NOTICE OF DECISION

**CLASS 3 SITE PLAN REVIEW / CLASS 2 ADJUSTMENT / CLASS 2 DRIVEWAY
APPROACH PERMIT CASE NO.: SPR-ADJ-DAP20-33**

**SITE PLAN REVIEW / ADJUSTMENT / DRIVEWAY APPROACH PERMIT
CASE NO. SPR-ADJ-DAP20-33
DECISION**

NEW BUILDING
FOR JOHNSON FAMILY
ORTHODONTICS

SHEET
A1.1

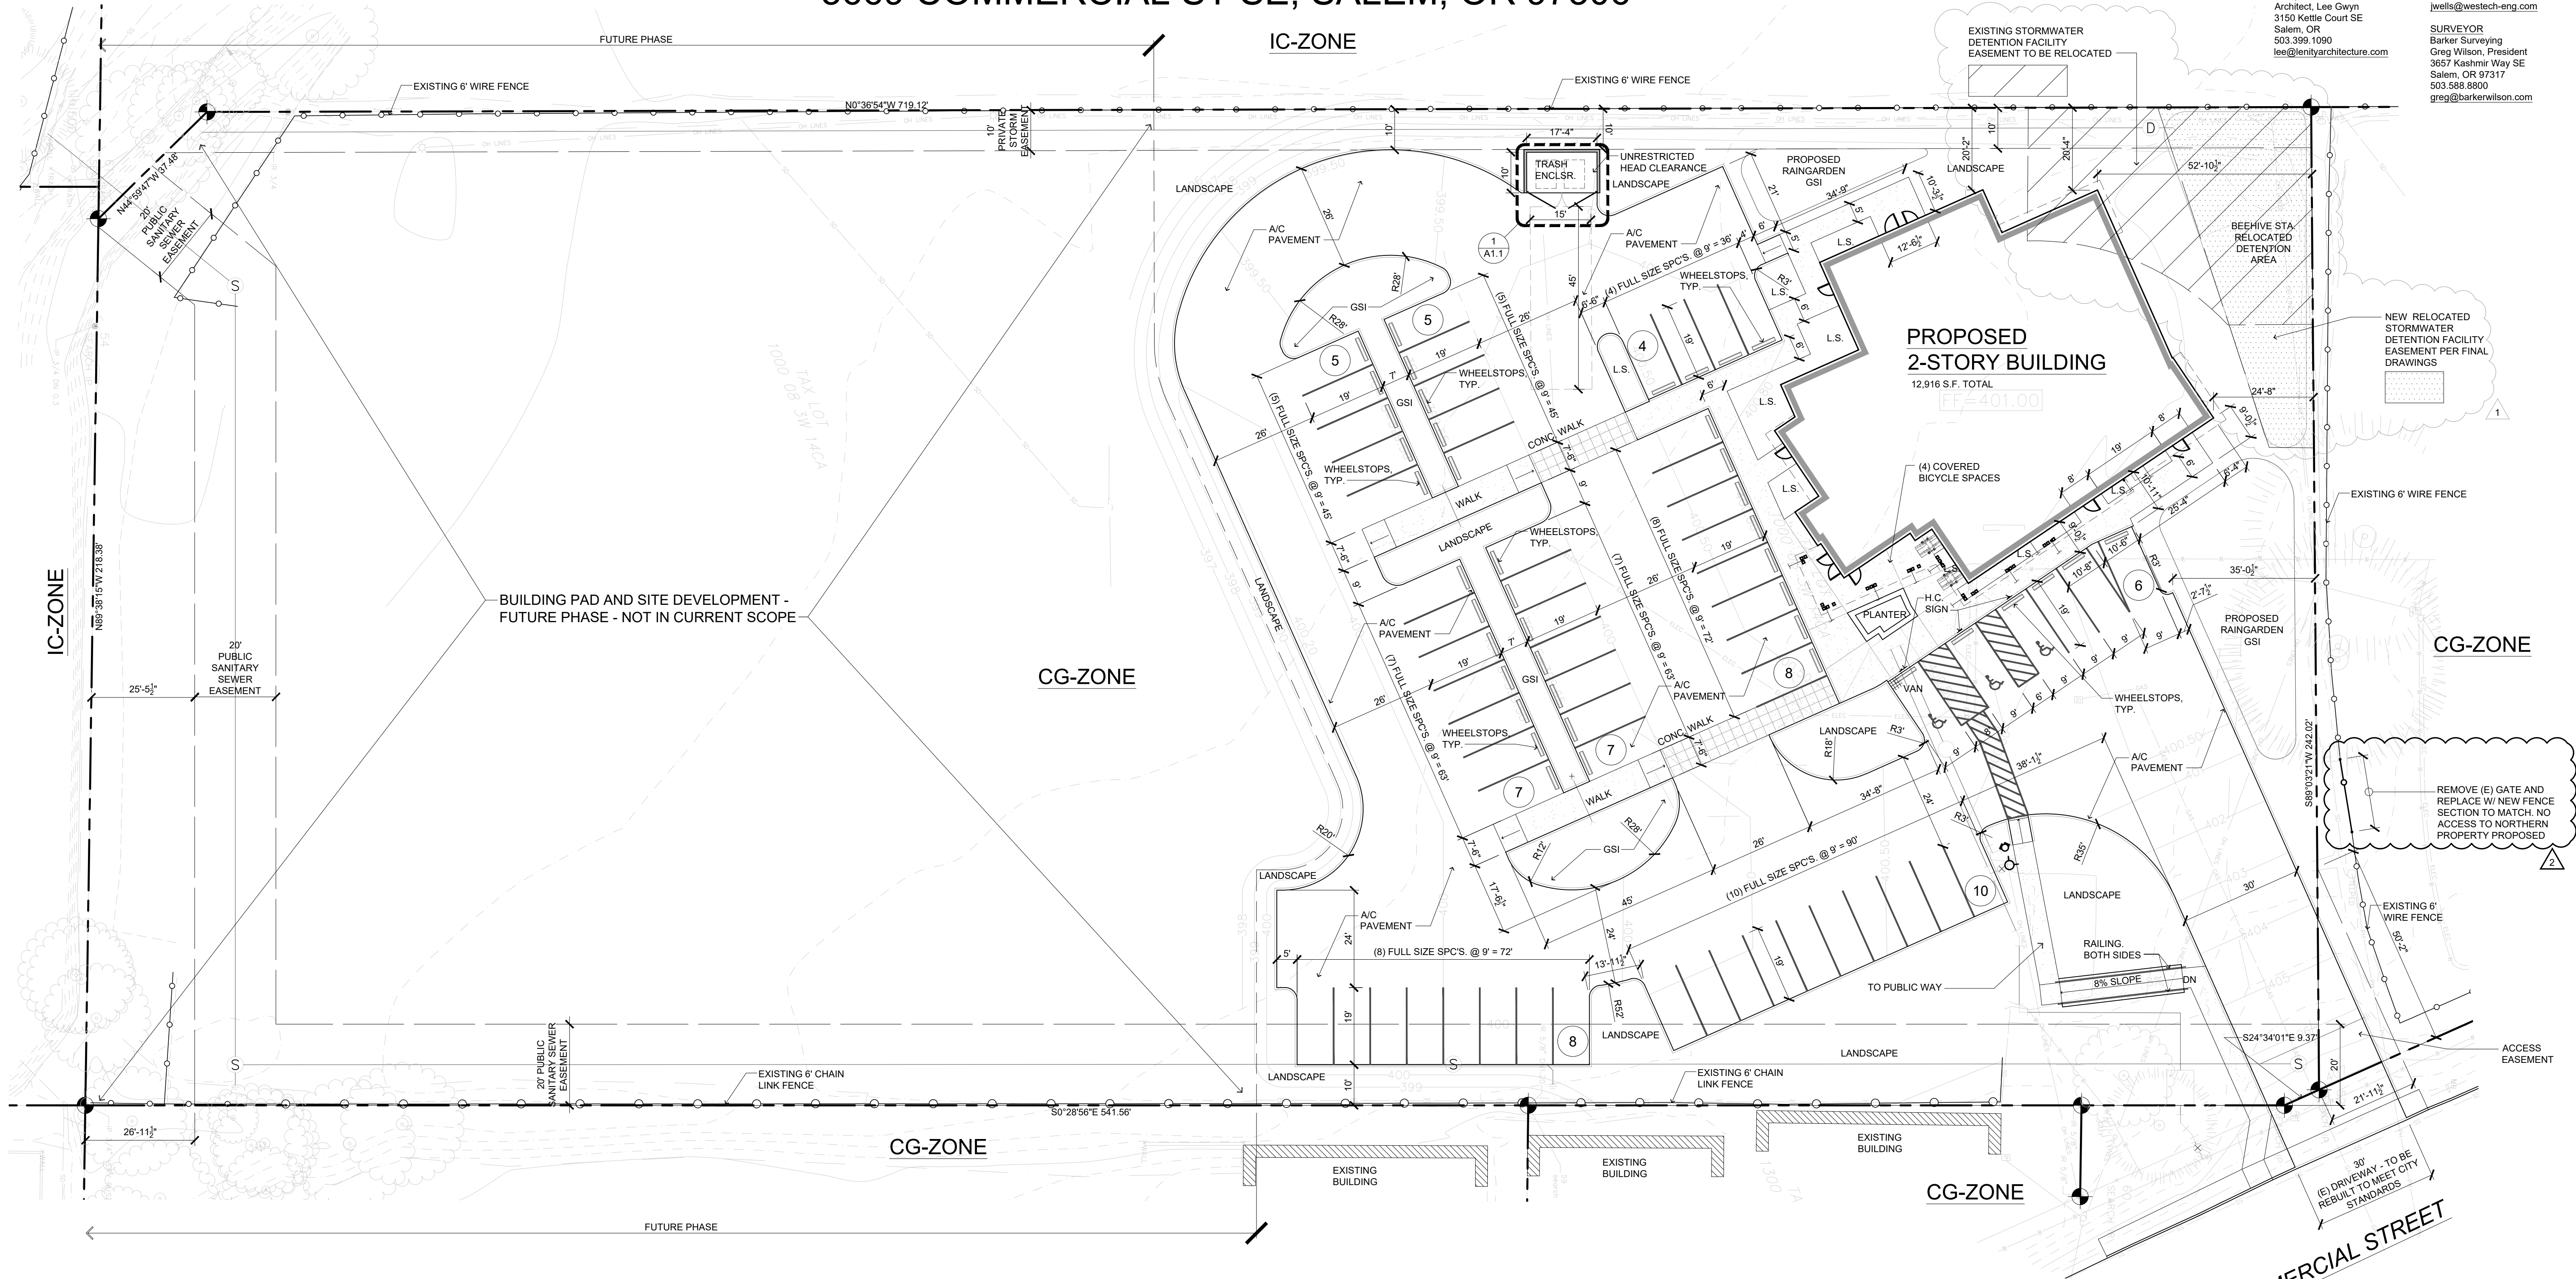
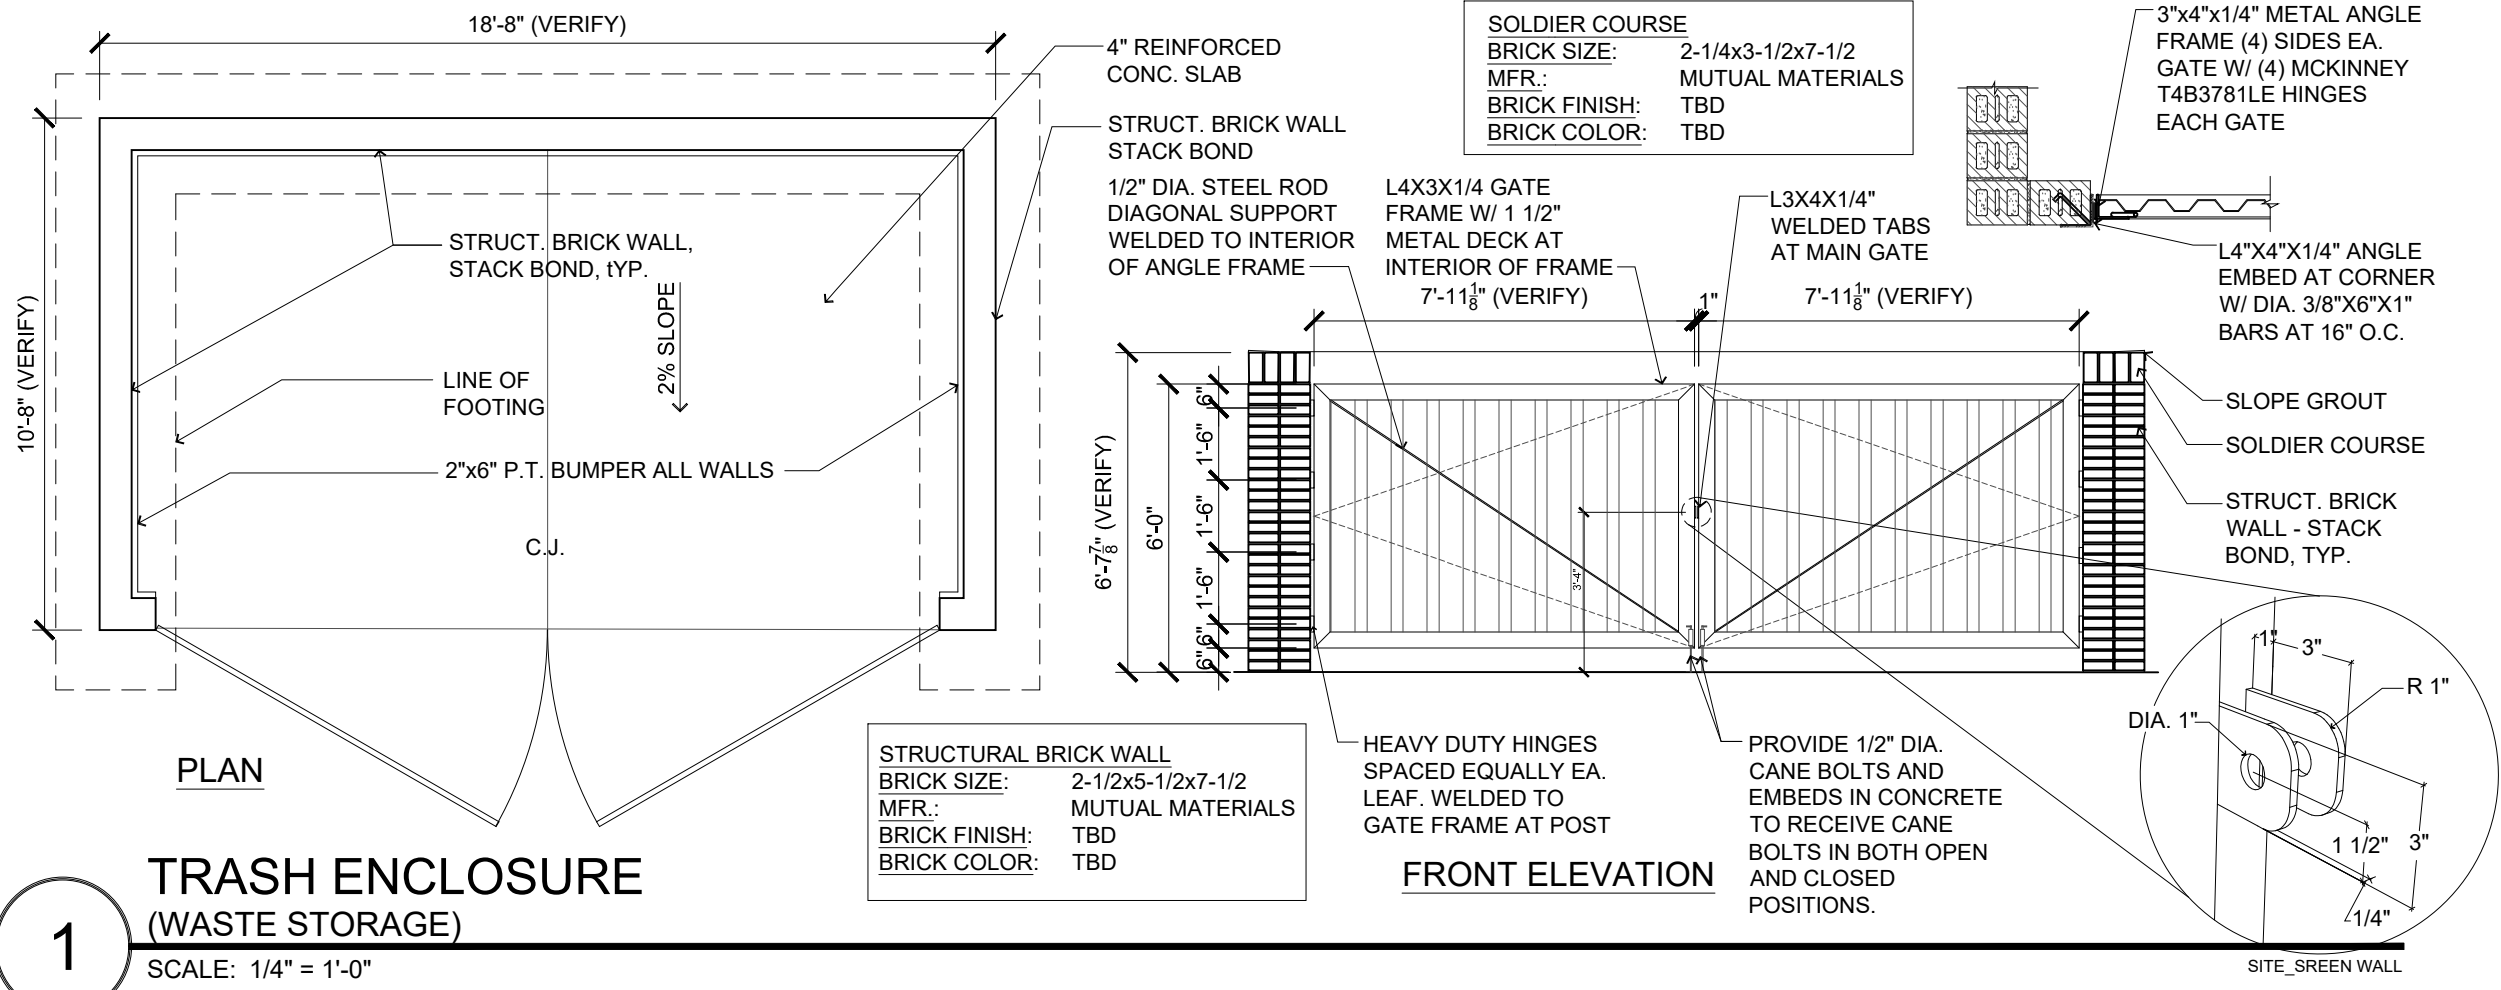
Finding: The proposed building is greater than 20-feet from the west and the north property lines, and greater than 100-feet from the south and the east property lines. There is an existing driveway serving the site which crosses the property line shared by

Condition 1: Prior to final building permit approval, the applicant shall obtain and record an access easement with the property owner to the north, ensuring continued access to the portions of the proposed driveway that are located on the adjacent property.

Finding: The site plan proposes a pedestrian connection from the main entrance of the building to the abutting right-of-way of Commercial Street SE. This standard is met.

Finding: The proposed off-street parking areas is greater than 25,000 square feet in size; therefore, this standard is applicable. The applicant proposes two pedestrian access pathways, approximately 71-feet apart, that connect the off-street parking area west of the building to the building entrances. This spacing of the pedestrian access pathways exceeds the minimum spacing standard of one connection for every 250 feet and one connection every two drive aisles.

Finding: The applicant is proposing 7.5-foot wide concrete walkways for the vehicle parking area to the south of the building, which meet the minimum pedestrian access design standards. The design and materials for the walkway from the main building entrance to Commercial Street SE is not indicated and the site plan does not demonstrate how the walkway will be separated from the vehicle use area. To ensure that this pedestrian walkway meets the applicable design standards established in SRC 800.065(b), the following condition applies:

Condition 2: As a condition of building permit approval, the applicant shall demonstrate the pedestrian accessway from the main building entrance to Commercial Street SE meets the design and materials standards for crossing vehicle use areas provided in SRC 800.065.

A private stormwater detention facility is located within an easement at the northwest corner of the subject property. This facility was designed and constructed to serve the northerly abutting property. No buildings or structures are allowed within this easement pursuant to PWDS and the terms of the easement. The site plan indicates the existing stormwater detention facility and easement will be modified to accommodate the proposed building footprint. To ensure compliance, the following condition applies:
